Project	<b>IEEE 802.16 Broadband Wireless Access Working Group</b> < <a href="http://ieee802.org/16">http://ieee802.org/16</a> >	
Title	<b>Signaling Acknowledgment Mechanism in MR Network</b>	
Date Submitted	<del>2007-04-23</del>	
Source(s)	Qu Hongyun, Mary Chion, Cancan Huang, Sean Cai Liu Yang, Chen Yuqin ZTE Corporation 712/2, Liantang Pengji Industrial Park, Luohu District, Shenzhen, P.R.China 518004  Mo-Han Fong  Nortel 3500 Carling Avenue Ottawa, Ontario K2H 8E9	Voice:+86-755-26773000 exd. 6614  Fax:+86-755-26773000 exd.  E-mail: <a href="mailto:mchion@zteusa.com">mchion@zteusa.com</a>
Re:	IEEE 802.16j-07/007r2:“Call for Technical comments and contributions regarding IEEE Project P802.16j”	
Abstract	This document presents sleep mode operations for IEEE 802.16j. The existing IEEE 802.16e messages are reused and new parameters are introduced in order to facilitate the sleep mode management in IEEE 802.16j.

## Signaling Acknowledgment Mechanism in MR Network

**Figure 20l – Acknowledgement Header**

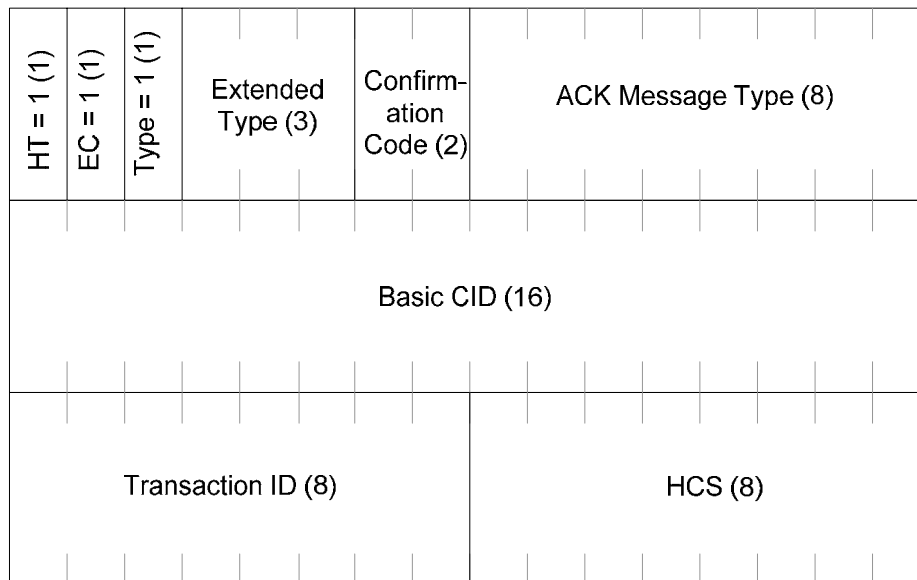
**6.3.2.1.2.2.3 Acknowledgment Header (ACK Header)**

An Acknowledgment Header is sent by an RS as a response to a MAC management messages received from the MR-BS or its superordinate RS that requires acknowledgment. The RS sends this header to the MR-BS or its superordinate RS as an indication of the message reception. The Acknowledgment Header shall be sent on RS’s basic CID. The Acknowledgment Header is illustrated in Figure 20l. The support of Acknowledgement header is optional for both MR-BS and RS and shall be negotiated during network entry of a RS using REG-REQ and REG-RSP message.

The Acknowledgment header shall have the following properties:

- a. This is a MAC signaling header type II. The length of the header shall always be 6 bytes.
- b. The Type field of this header shall be set to 1.
- c. The Extended Type field of this header shall be set to 0b010
- d. The content of the header is listed in table 7k.
